Sub: Proposal for diversion of 0.4305 Ha of forest land for construction of Rural Connectivity Road from Lingdok 9th Mile to Dikchu Bazar at Lingdok in Gangtok District of Sikkim by Rural Development Department, Govt. of Sikkim under Forest Conservation Act, 1980; Addl information reg.

Proposal No. FP/SK/ ROAD/121630/2020

Sub: Proposal for diversion of 0.4305 ha of forest land for construction of road from Lingdok 9th Mile to Dikchu Bazar at Lingdok in East Sikkim – Additional Information -reg.

MUCK DISPOSAL PLAN

SITE PLAN FOR MUCK DISPOSAL

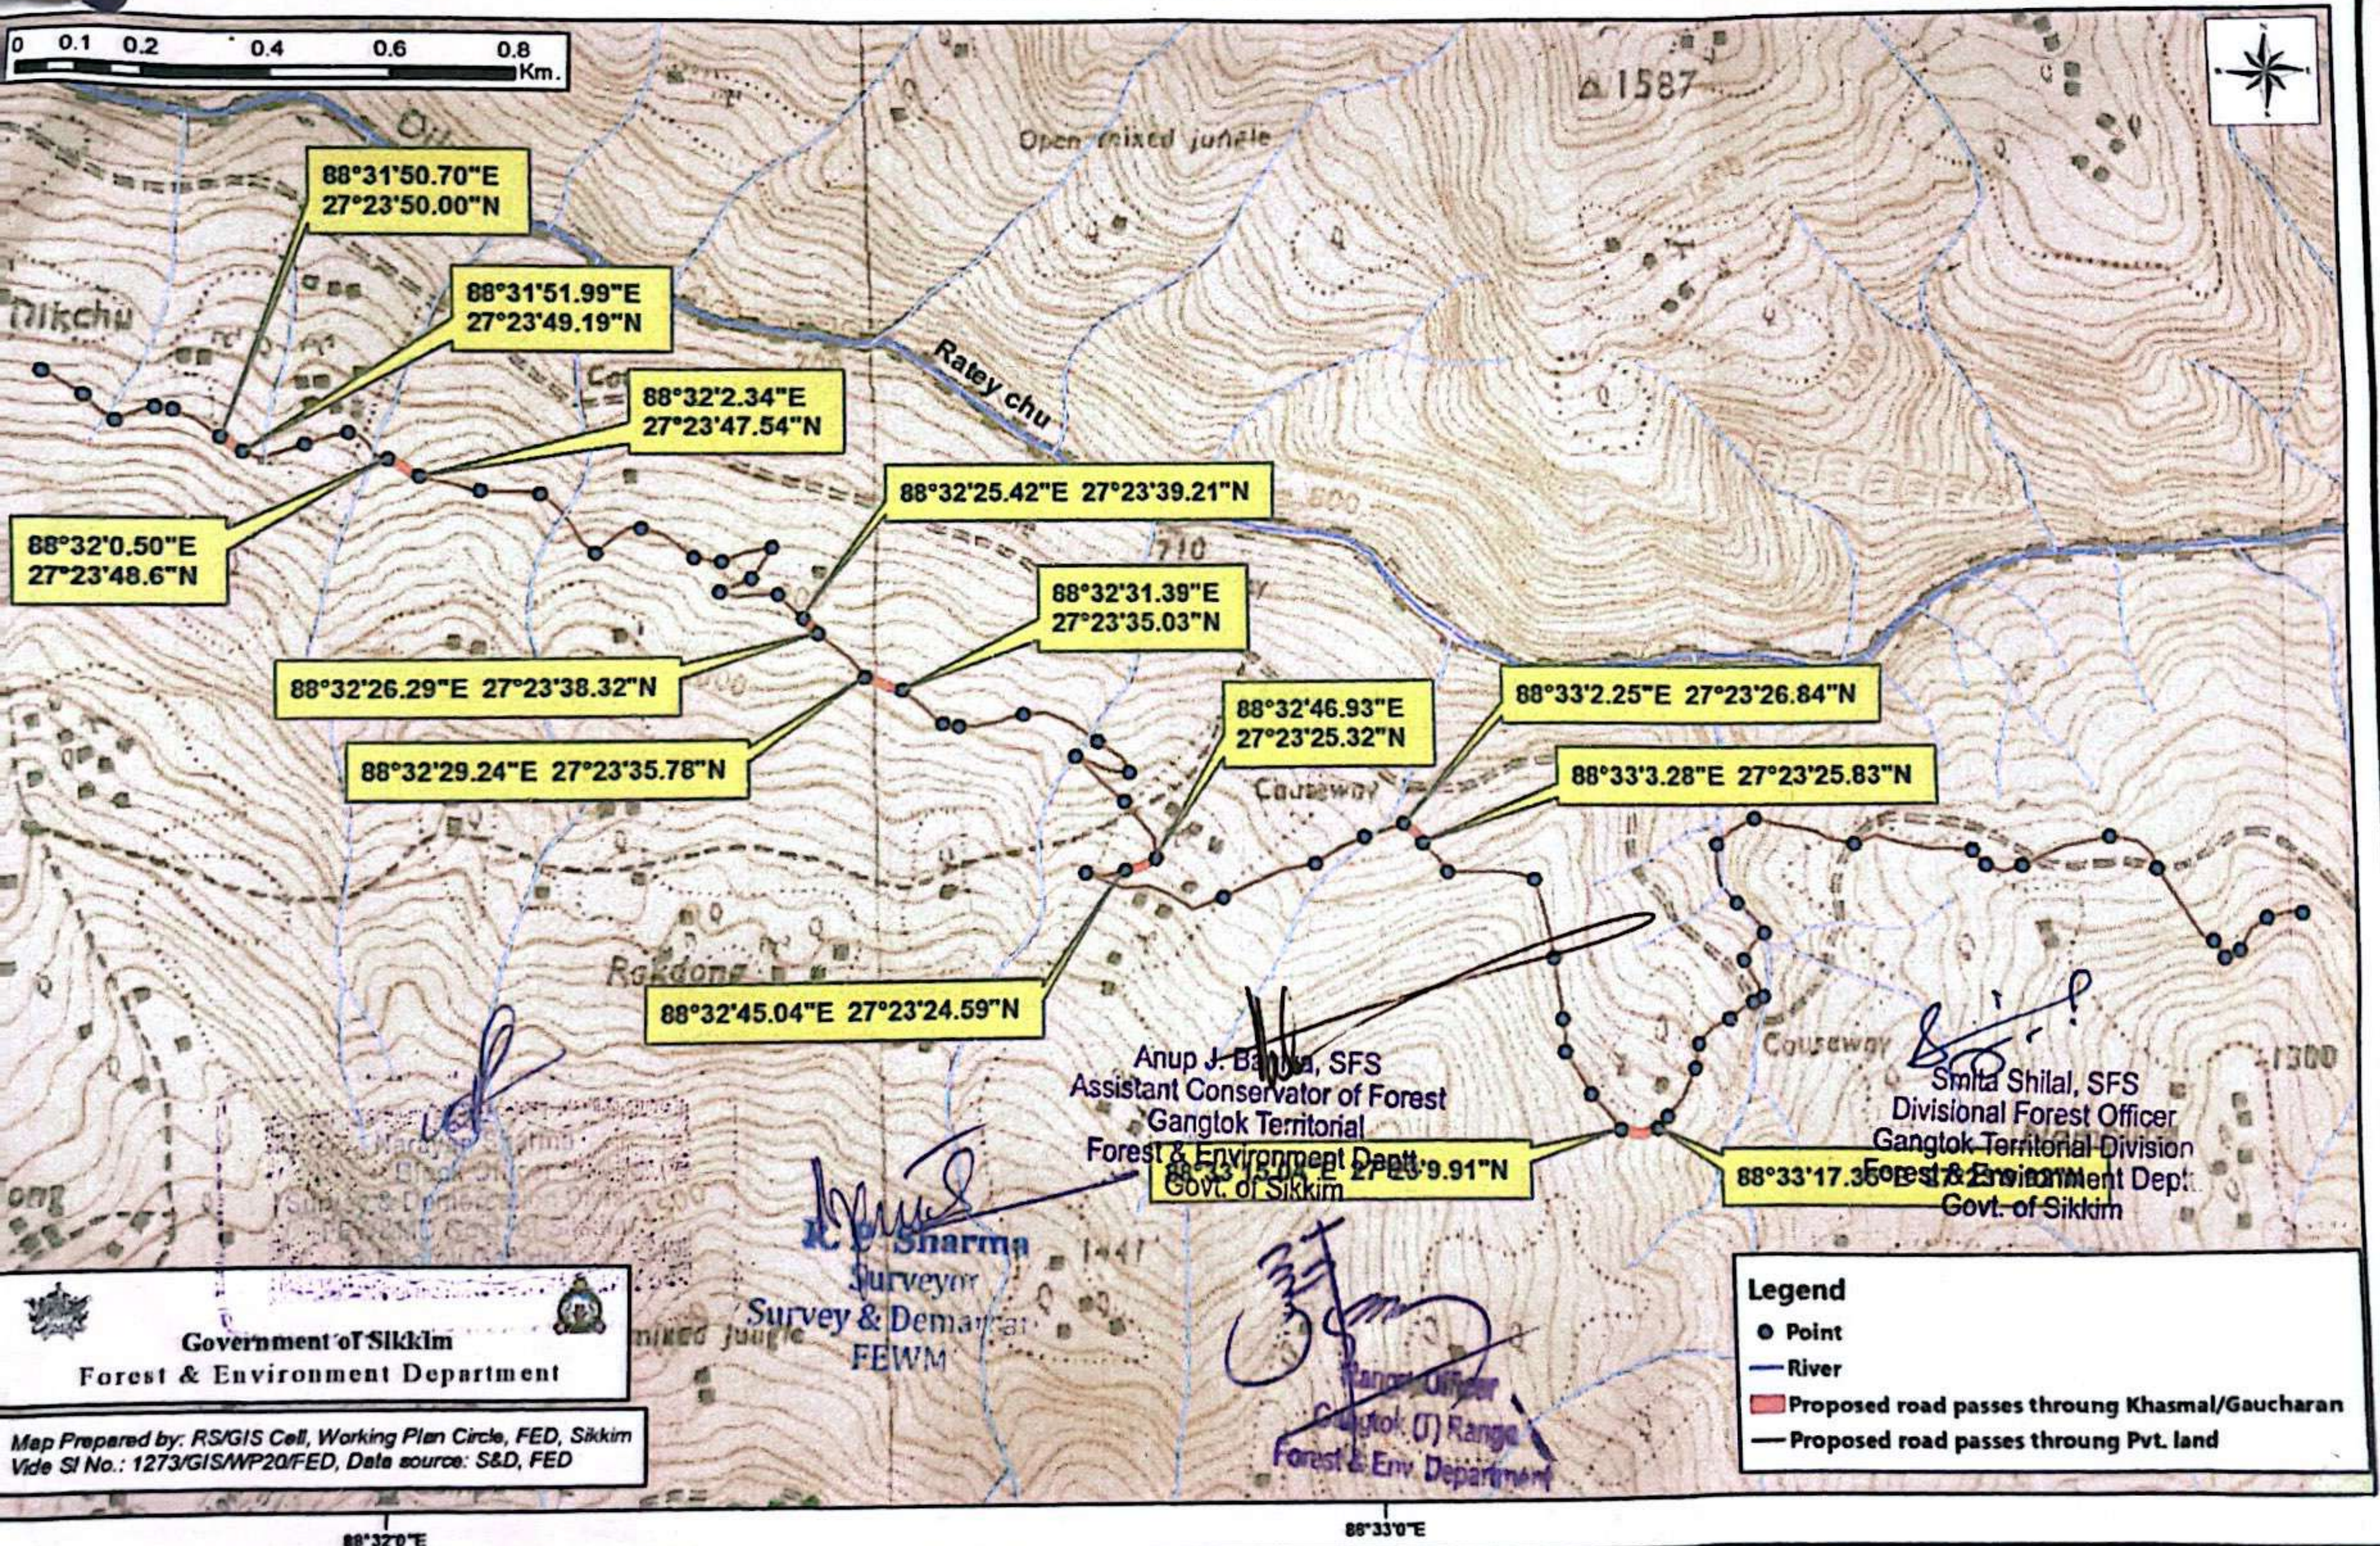
4	The Muck Dumping Plan signed by competent authority showing quantity of muck to be generated and quantity of muck to be used in the construction needs to be furnished by the User Agency.	The muck dumping plan, quantity of muck generated, balanced quantity and muck dumping area submitted by user agency is enclosed and uploaded on PARIVESH portal.
5	Sol toposheet map along with GPS coordinates and land Patta is to be furnished by the User Agency for Muck dumping area.	Sol toposheet map with GPS coordinates and land Patta (parcha) for Muck dumping area alongwith NOC from land holder furnished by the user agency is enclosed and uploaded on PARIVESH portal.

The muck dumping plan giving at least quantity of muck to be generated, quantity to be used in the construction, balance quantity and the muck dumping area details with Sol toposheet map along with GPS coordinates is to be furnished.

Map Showing the location of Forest land at Tumin RF for Compensatory Afforestation in lieu of diversion of 0.4305 ha of forest land for construction of Lingdok 9th mile to Dikchu bazar at Lingdok in East Sikkim under Gangtok (T) Range. Area : 0.86 ha

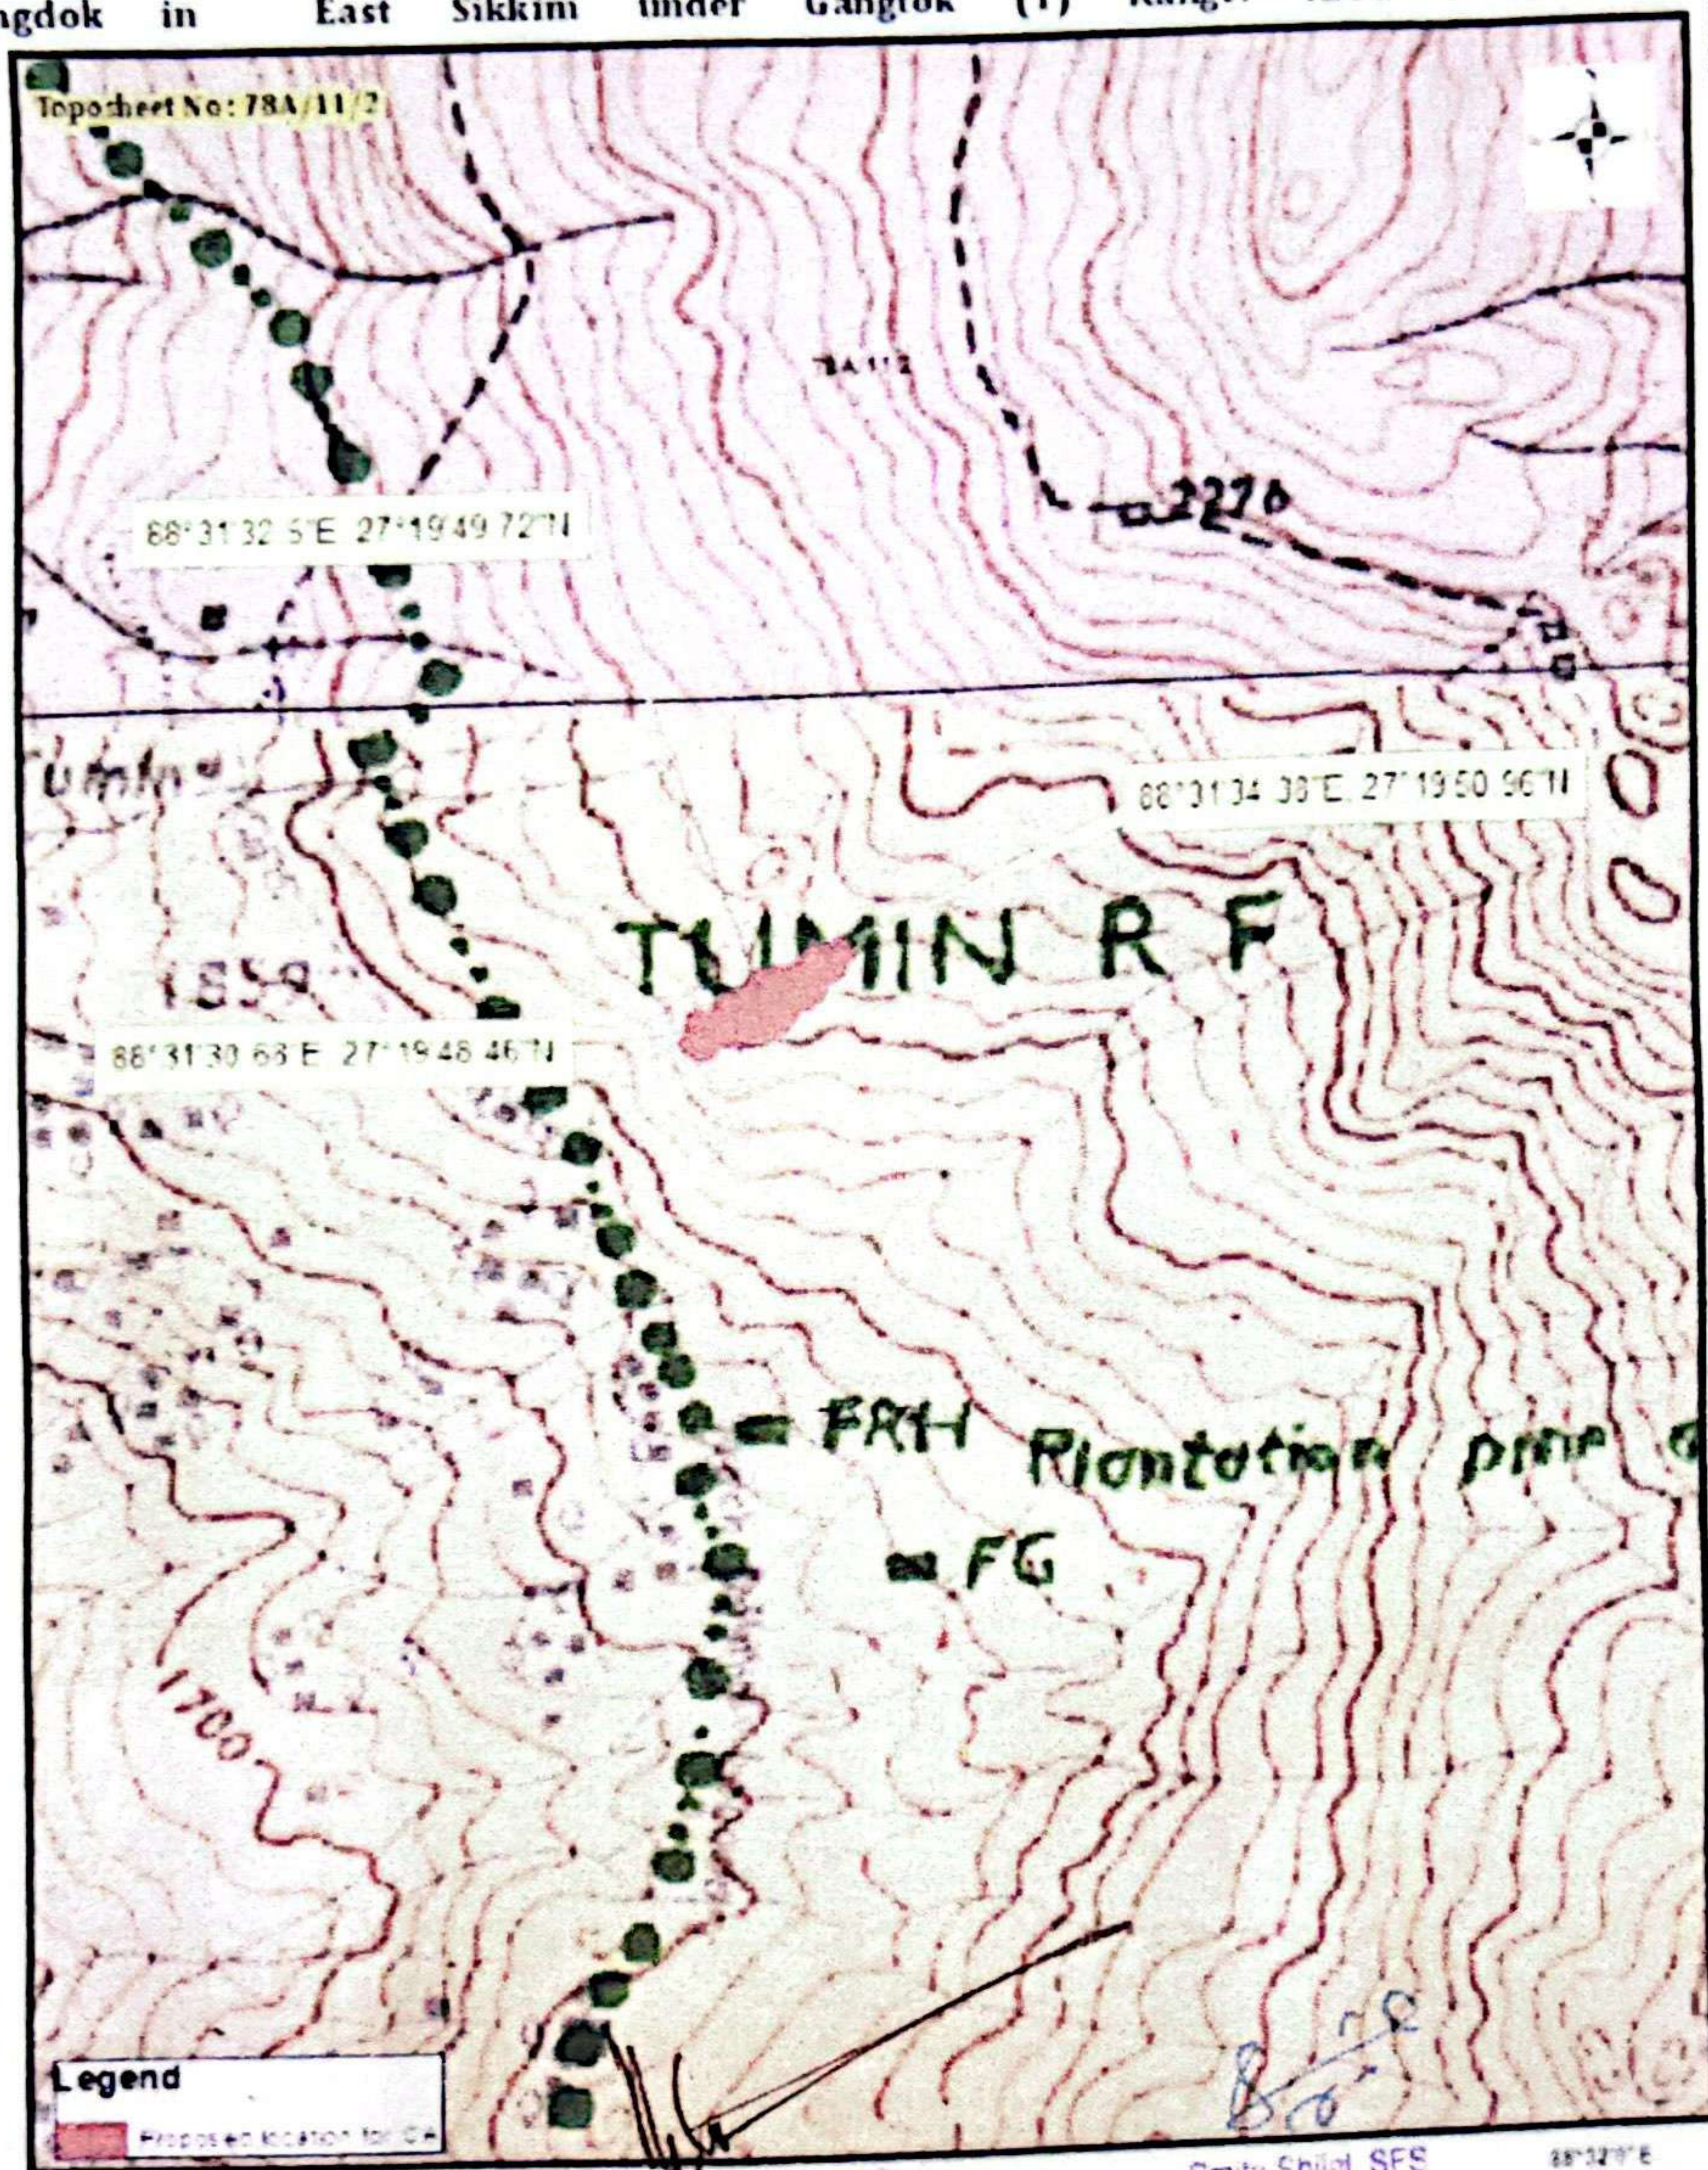
SN	Additional information sought	Reply to Addl. information
1	As per DSS report the diversion area is found 0.051375 ha which is less than the proposed area and CA area observed in moderate dense Forest. Therefore, concerned DFO may select a new site.	New site for Compensatory Afforestation has been selected. Details enclosed and uploaded.
2	As per submitted Sol toposheet map, the proposed areas are shown on 6 individual patches. But in Part I single Kml/shape has been uploaded. User Agency is required to reupload remaining diversion area KML/shape files.	As reported by the user agency, corrected KML/shape file of the total area and of all the forest area has been uploaded on PARIVESH portal.
3	Geo-reference Map of project site and C.A. land indicating longitude and latitude proposed forest land for diversion is to be furnished.	Geo-reference Map of project site and C.A. land indicating longitude and latitude is enclosed and uploaded on PARIVESH.
